VIRGINIA ELECTRIC AND POWER COMPANY
RICHMOND, VIRGINIA 23261

VIRGINIA ELECTRIC AND POWER COMPANY (DOMINION)
NORTH ANNA POWER STATION UNITS 1 AND 2
PROPOSED LICENSE AMENDMENT REQUEST
ADDITION OF LCO 3.0.8 - INOPERABILITY OF SNUBBERS
USING THE CONSOLIDATED LINE ITEM IMPROVEMENT PROCESS
TECHNICAL SPECIFICATION IMPROVEMENT

Marked-up Technical Specification Changes

3.0 LCO APPLICABILITY

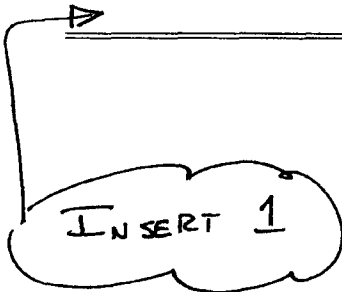
INSERT 1

LCO 3.0.8 When one or more required snubbers are unable to perform their associated support function(s), any affected supported LCO(s) are not required to be declared not met solely for this reason if risk is assessed and managed, and:

- a. the snubbers not able to perform their associated support function(s) are associated with only one train or subsystem of a multiple train or subsystem supported system or are associated with a single train or subsystem supported system and are able to perform their associated support function within 72 hours; or
- b. the snubbers not able to perform their associated support function(s) are associated with more than one train or subsystem of a multiple train or subsystem supported system and are able to perform their associated support function within 12 hours.

At the end of the specified period the required snubbers must be able to perform their associated support function(s), or the affected supported system LCO(s) shall be declared not met.
